FILE: X096329.003 DATE: 16 November 2023

SUBJECT: Information Relevant To Item 11.5 – Post Exhibition - Planning Proposal -

85-93 Commonwealth Street, Surry Hills - Sydney Local Environmental Plan

Proponent Submission by SJB Planning to the 6 November 2023 Transport, Heritage and Planning Committee

Figure 1: 4.5:1 FSR

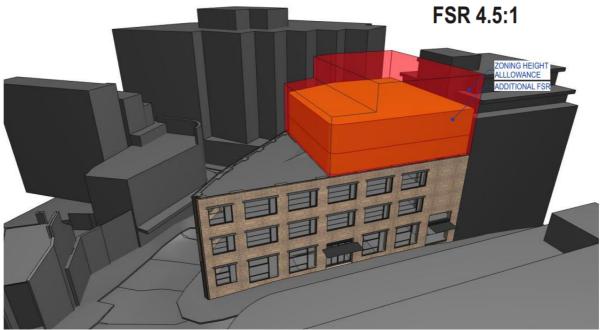
- 3. The proposed envelope has been amended to ensure that there are no overshadowing impacts on neighbouring properties and public spaces. The maximum FSR of 4.5:1 readily fits within this envelope as illustrated in Figure 1.

- 6. The imposition of a 4.1:1 base FSR, means a 2 storey addition cannot be realised without going through a Design Competition as illustrated in Figure 2.

We request that the maximum 4.5:1 FSR control be reinstated, without the requirement for a Design Competition to be held.
